Attachment 1

Replacement Pages of the Planning Statement

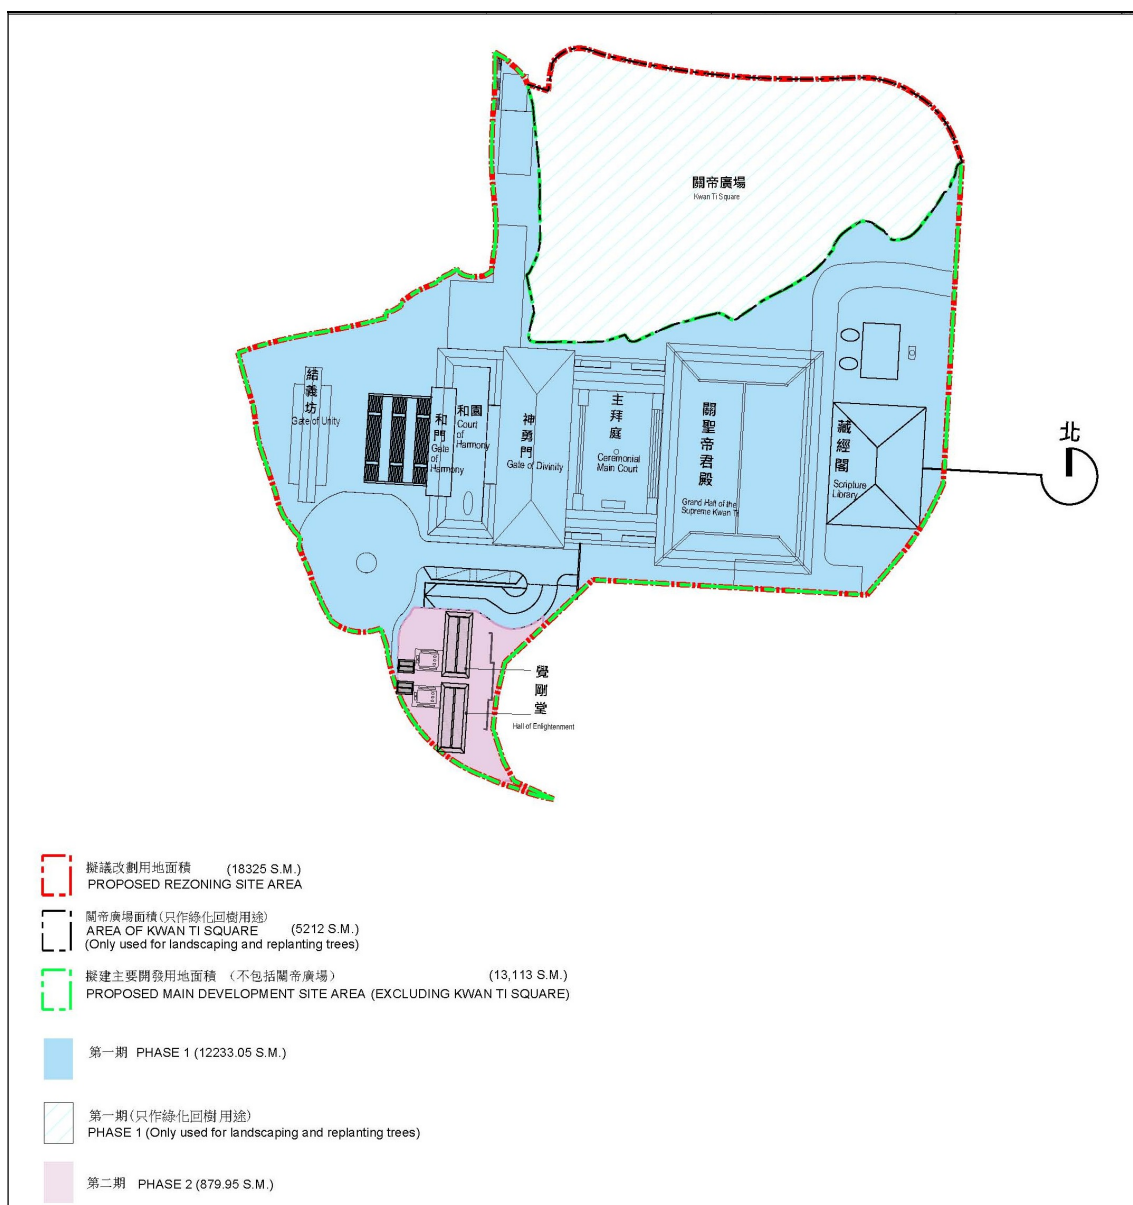
It is proposed to discharge the stormwater runoff from the site to the existing stream to the west of the site. **Peripheral surface stormwater drains and catchpits will be provided within the site boundary to collect surface runoff from the proposed development, as well as runoff from the surrounding catchments that is conservatively assumed to overflow onto the site. Runoff from Catchment A, together with runoff from Catchment B and G, which is conservatively assumed to overflow into Catchment A, will be conveyed to the proposed discharge point connecting to the stream located to the west of the site. Underground circular drains of Ø 1,050mm at a gradient of 1 in 200 are proposed for stormwater conveyance.**
